ASSESSMENT REPORT

Hunter Valley Operations - Carrington Pit Extension

On 7 October 2005, the Applicant lodged a modification application (MOD 166-10-2005) under section 96(2) of the *Environmental Planning and Assessment Act 1979* (EP&A Act) and an accompanying Statement of Environmental Effects (SEE). The proposed modification involves (see Figure 2):

Figure 3: Hunter River palaeochannel and approved and proposed Carrington Pit mining operations (after Mackie, 2005).

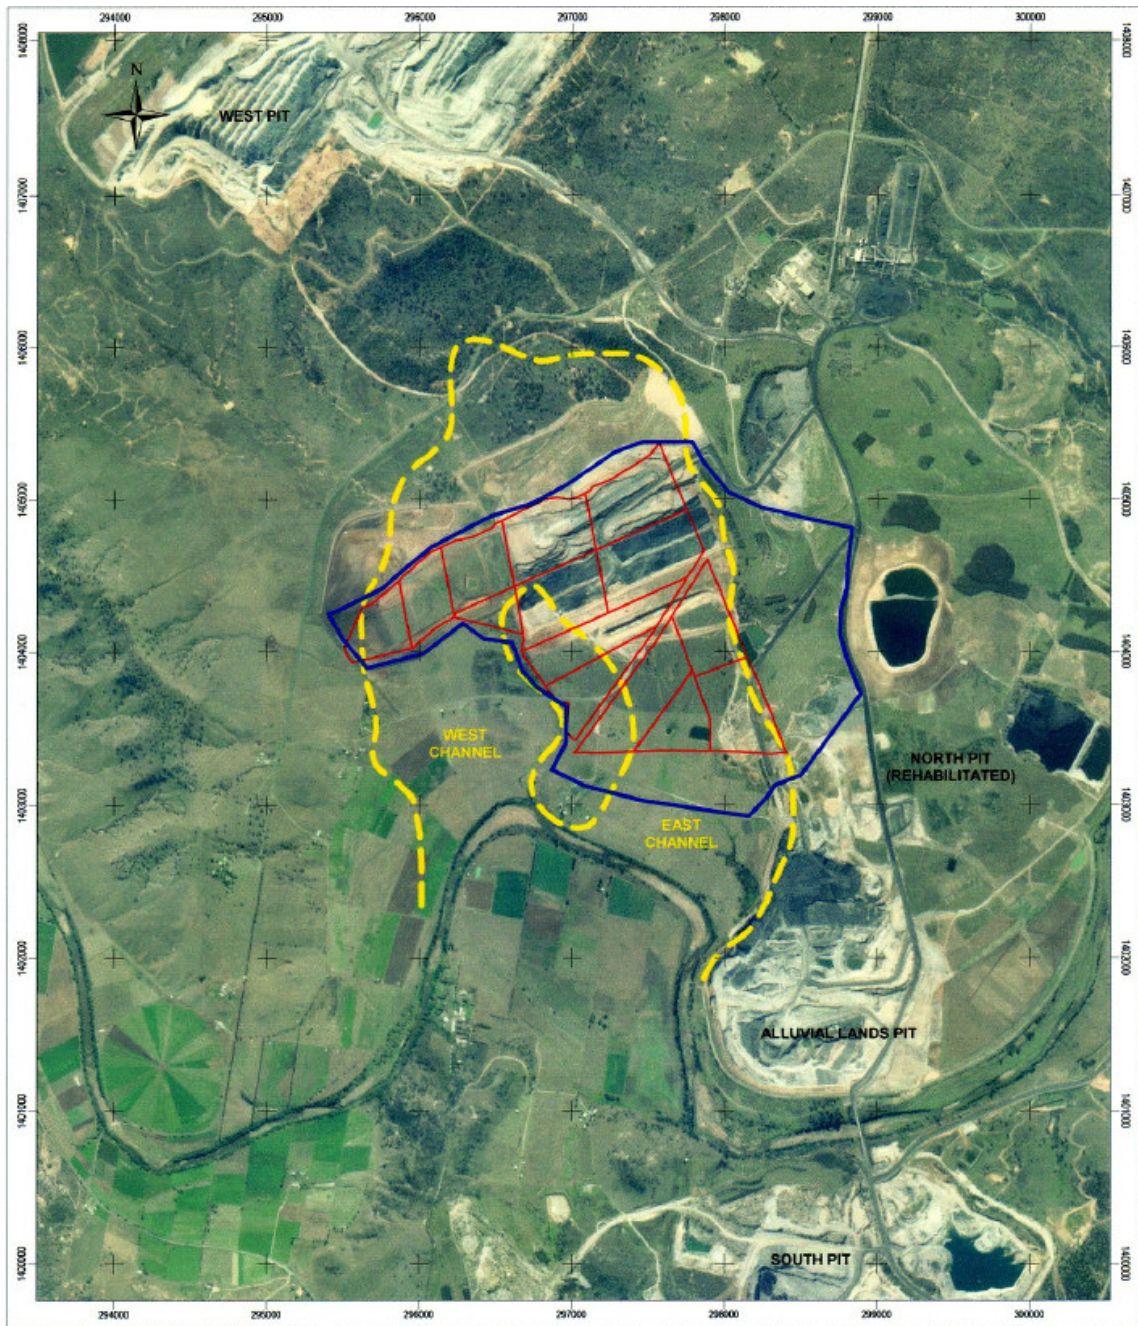
Even though the predicted flows are not large, the Department, DEC and DNR are all concerned at the loss of water from the river through the alluvium and into the Carrington Pit. Of equal concern to agencies is that, after mine closure and the re-saturation of spoils within the pit, highly saline groundwater may migrate into the alluvium and thence to the river.

The SEE reports that leakage from the river can be greatly mitigated by installation of “cut off” walls (i.e. groundwater barrier walls) across the palaeochannel. Such walls would also substantially inhibit long term leakage of saline leachate from spoils

southward into the undisturbed alluvium. A similar barrier wall has been successfully used by the Applicant at its Alluvial Lands Pit which is southeast of the proposed southern extension. Even so, the SEE did not advance a barrier wall as a firm component of the proposed modification, but rather as a potential element subject to further modelling and the views of agencies. The Applicant has since accepted the view of agencies that a barrier wall across the eastern arm of the palaeochannel is required.

MER's simulations are based on the installation of barrier walls across both the east and west arms of the palaeochannel. The SEE does not generally advance or discuss the proposal for the western barrier wall and it is true that the proposed southern extension would encroach much closer to the Hunter along the eastern arm of the palaeochannel (between 440 and 650 metres) than is currently proposed along the western arm (around 1150 metres). Consequently, the Department is generally satisfied that a second barrier wall on the western arm of the palaeochannel is not necessary for the proposed extension, but notes that if at some future time the Applicant seeks to mine closer to the river in this area a barrier of some kind is likely to be required.

In summary, the Department believes the Applicant should be required to construct a groundwater barrier wall across the eastern arm of the palaeochannel within 2 years of approval of the modification (or as otherwise agreed with the Director-General). The Department is generally satisfied that this would effectively prevent leakage from the Hunter River alluvium into the Carrington Pit.

However, the preferred location and design of the groundwater barrier is yet to be finalised. Consequently, the Department believes that the Applicant should be required to investigate all reasonable and feasible design options for the barrier and provide a report on these investigations (including a recommendation as to the preferred option) to the Department and DNR within 6 months. The Department, in consultation with DNR, would then be able to consider the best design for the barrier, prior to the Applicant proceeding with its construction.

Figure 4: Carrington River Red Gums, Billabong and Groundwater Barrier Wall

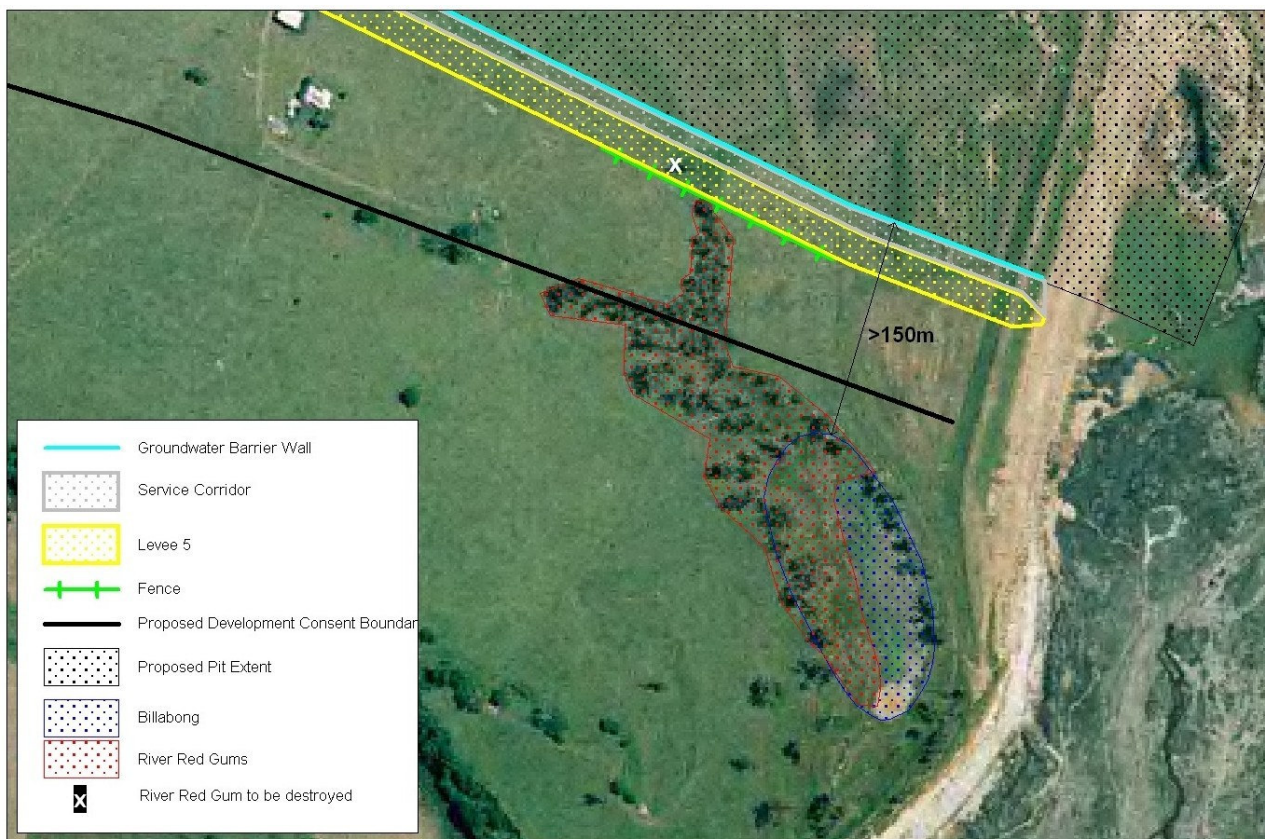
The small billabong located south of the proposed extension is an important local surface water feature (see Figures 3 and 4). The billabong supports a substantial surrounding population of 33 mature river red gums (*Eucalyptus camaldulensis*) covering some 0.4 ha. This species is listed as an endangered population throughout the Hunter Catchment under the *Threatened Species Conservation Act 1995*, with only 19 stands totalling some 15 – 20 ha known to remain. The billabong and river red gums are located on land owned by the Applicant.

The SEE's Ecology Assessment (see Annex H) reports that the river red gums are suffering from various stages of dieback, with a high proportion (22%) of standing dead (i.e. stag) trees. This in turn leads to a high number of tree hollows (86 recorded) which are useful habitat for birds, bats and tree-dwelling mammals. The SEE has suggested that dieback of the river redgums may in part be associated with the dewatering of the Carrington Pit (see Annex H). Other factors are likely to be the current drought and a likely reduction in the size and number of Hunter River floods over the past 50 years due to increased pumping. The SEE reports that, since 2001, pit dewatering has lowered the water table at the billabong by 2 – 3 metres. When inspected, the billabong was dry and its surface was dominated by exotic weeds (see Figure 5 and Annex C to the SEE).

Since the groundwater level is already close to the river level, and a barrier wall is proposed as a condition of consent, dewatering is unlikely to further impact on the billabong. However, given the lowered water table, it can be expected that the billabong would remain dry until the next major flood event, which may be some years.

The Applicant has agreed to requests from DNR that the pit highwall be separated from the standing water line of the billabong by a buffer of 150 metres. It is proposed that Levee 5, a services corridor and a fence would be constructed close to the highwall within this buffer (see Figure 4). Careful location of the levee and the services corridor would result in the destruction of a single mature tree from the upstream edge of the red gum population.

Given the regional significance of the red gum population, the existing impacts of dewatering on the billabong, the poor condition of both the billabong and the red gums, and that the Applicant owns the land, the Department believes that there is an outstanding

opportunity for a regionally-significant ecosystem restoration and rehabilitation program. It is clear that such a program needs to address the fundamentals underpinning the health and sustainability of the billabong and the red gums, such as surface water, groundwater and ecosystem re-establishment, as well as lesser matters such as weeds, exclusion of cattle and fencing.

A condition of consent has therefore been proposed which requires the Applicant to develop a comprehensive rehabilitation and restoration program for the billabong and river red gum population.
